ADDENDUM #2
BID NUMBER: 24-11

ESPLANADE BUILDING 4 ELEVATOR ADDITION

Please note the following clarification to Bid Number 24-11:

UTIL-LOCATE SUBSURFACE UTILITY MAP

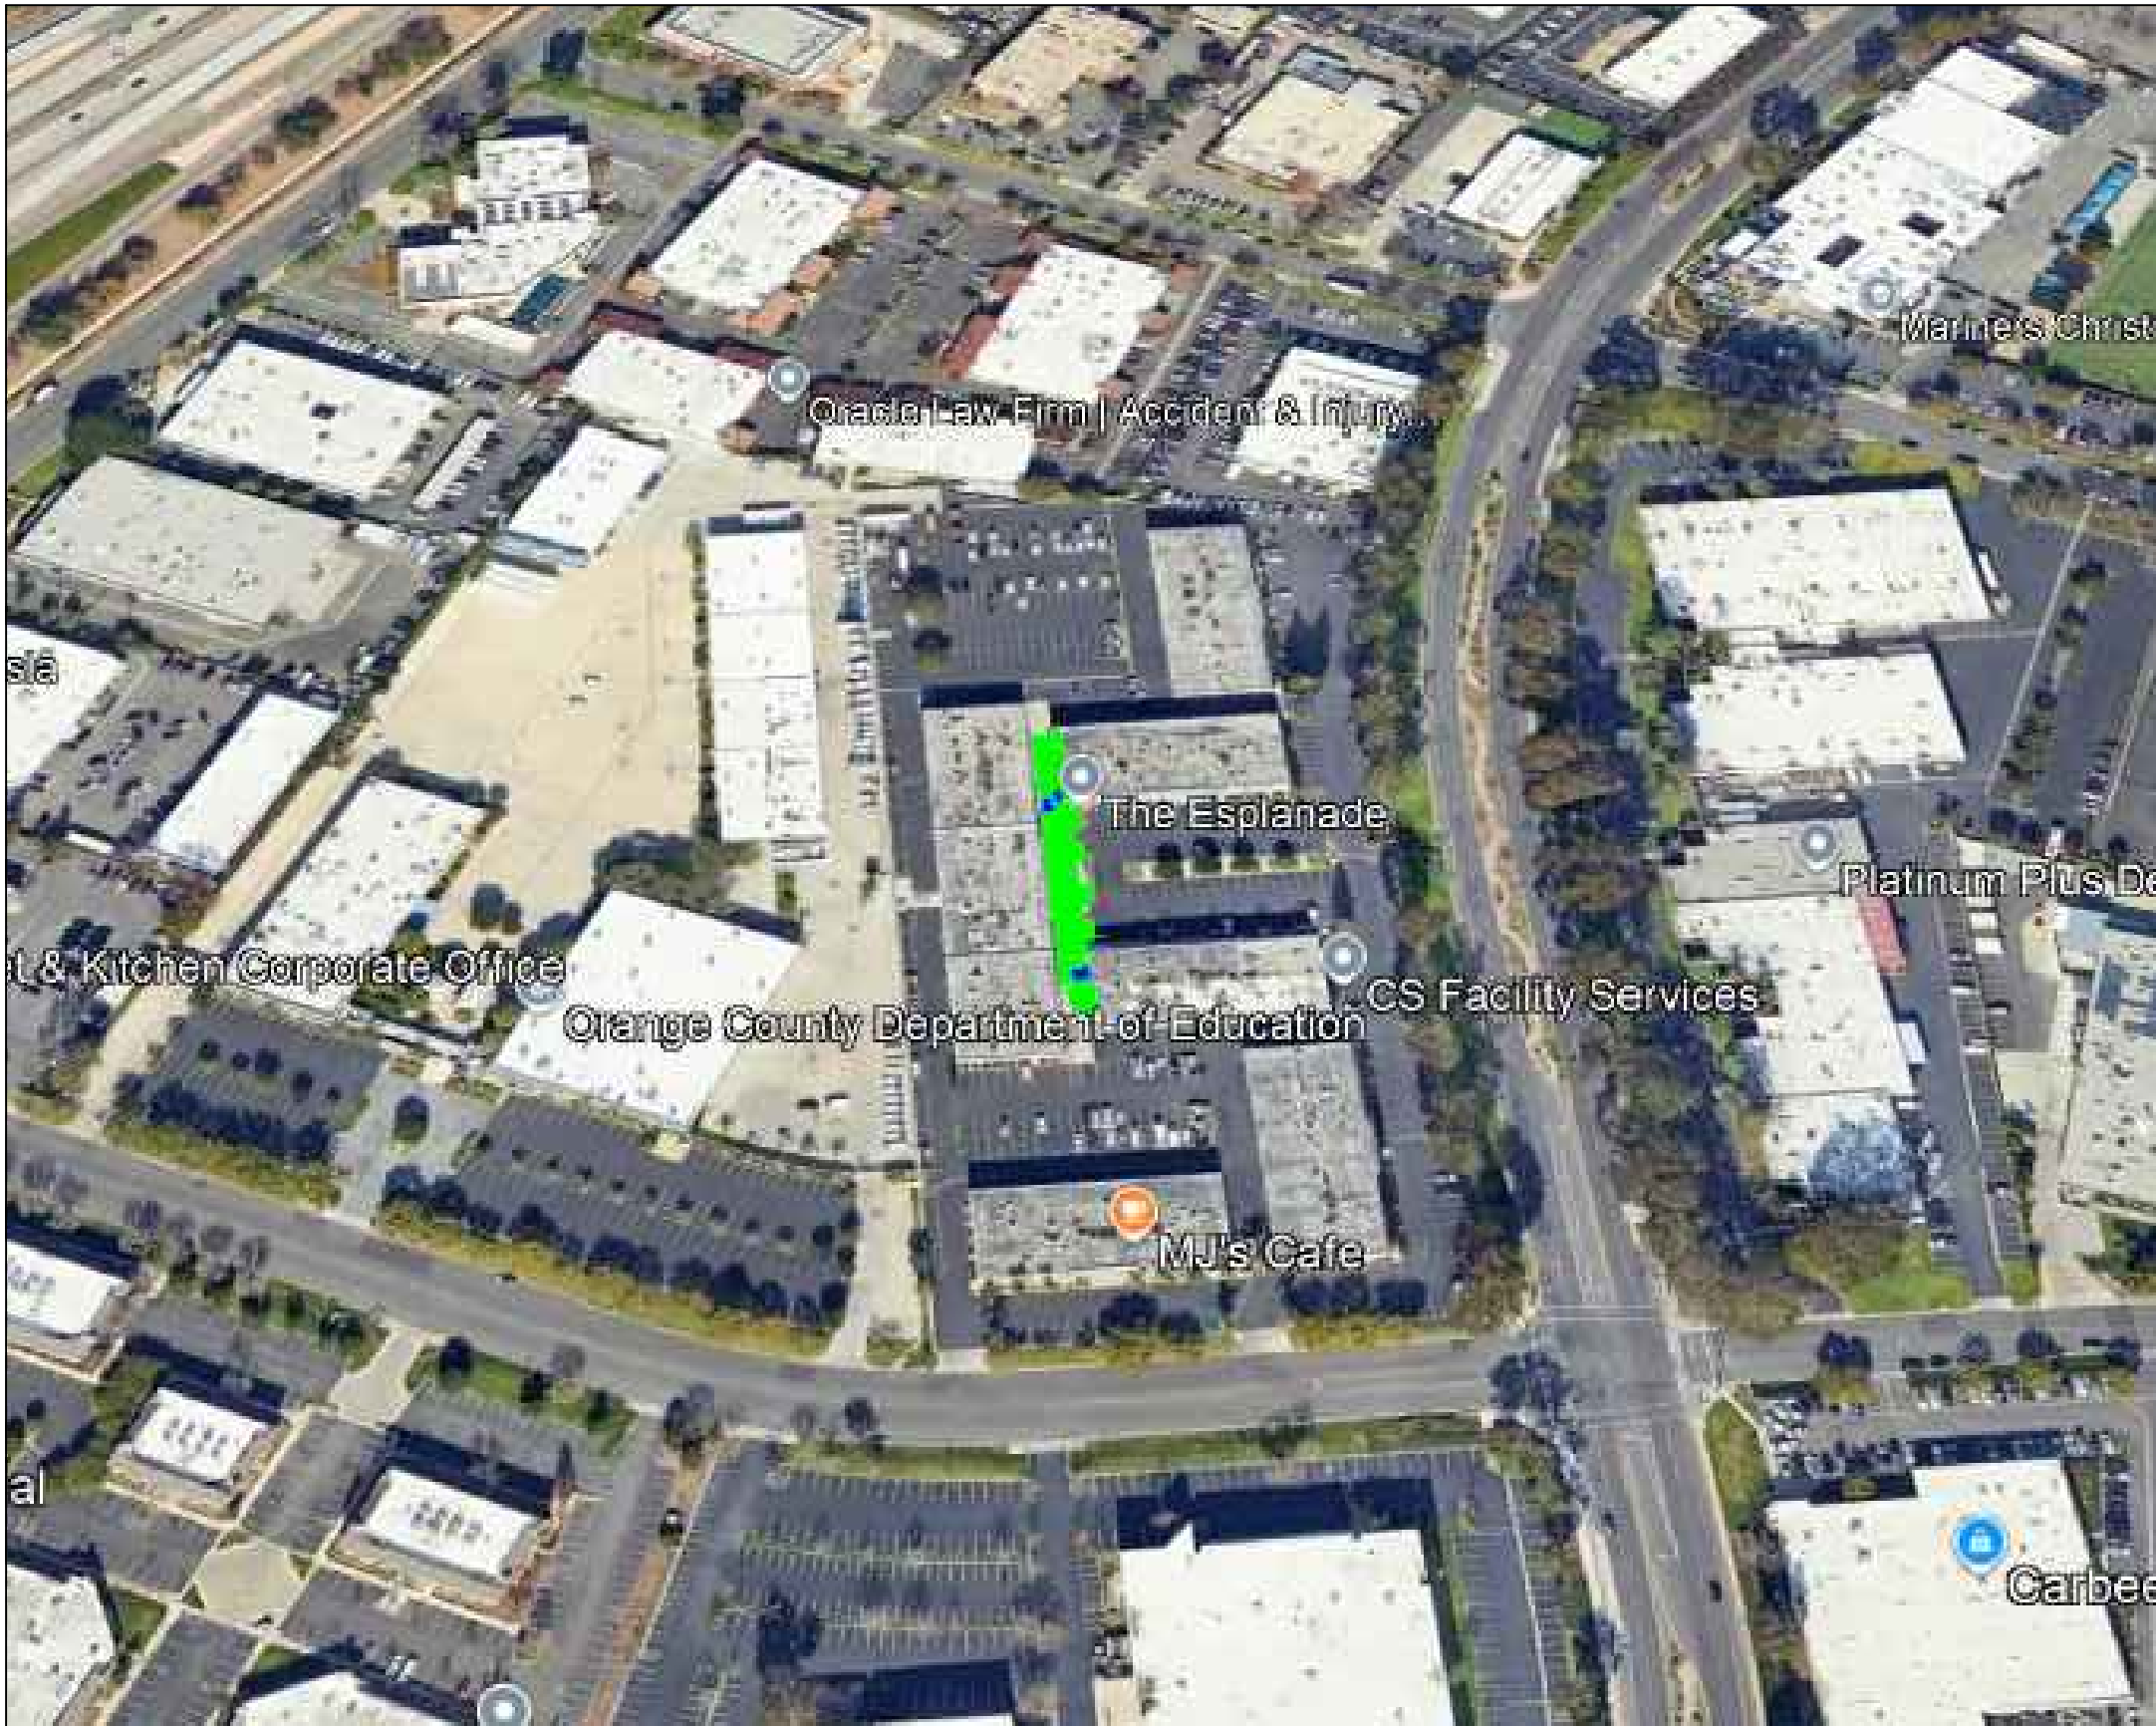
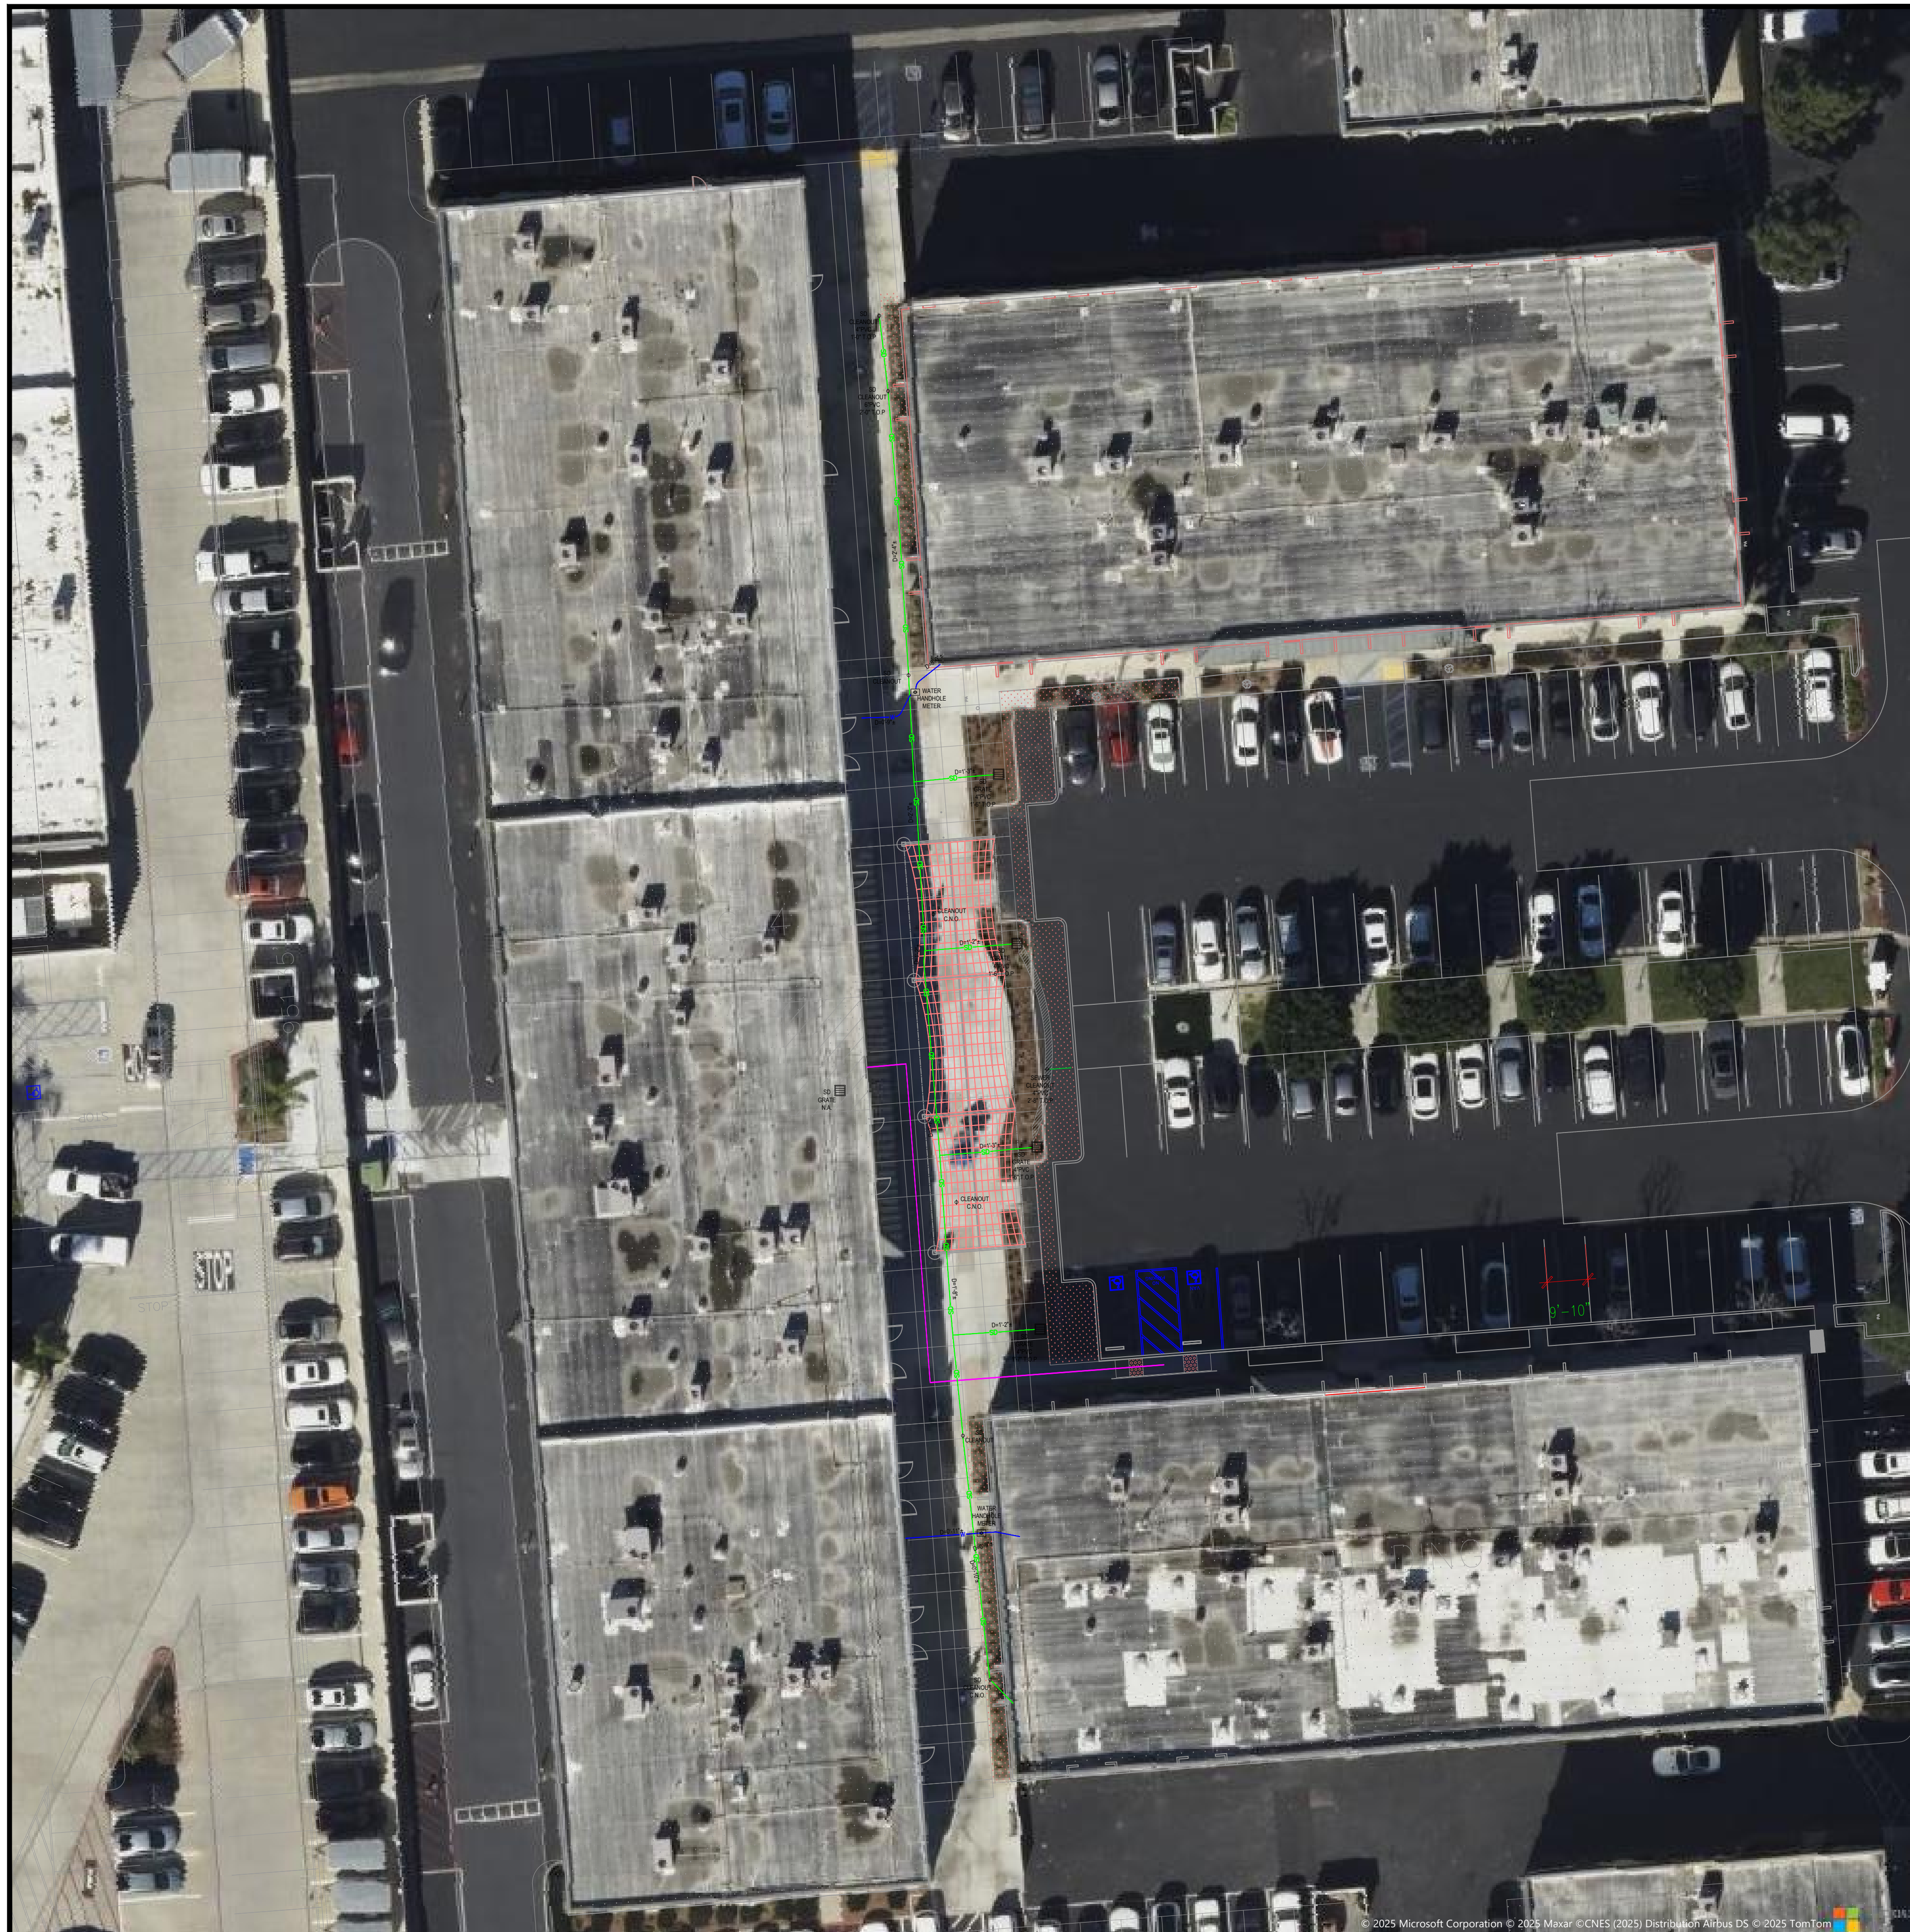
1. Conduit Roof Penetration: Refer to attached Siplast Roofing detail, Sketch ASK-4, for optional conduit routing across roof. Use Dura-Blok supports as sleepers for roof top conduit.
2. Attached is Utility Mapping for reference.
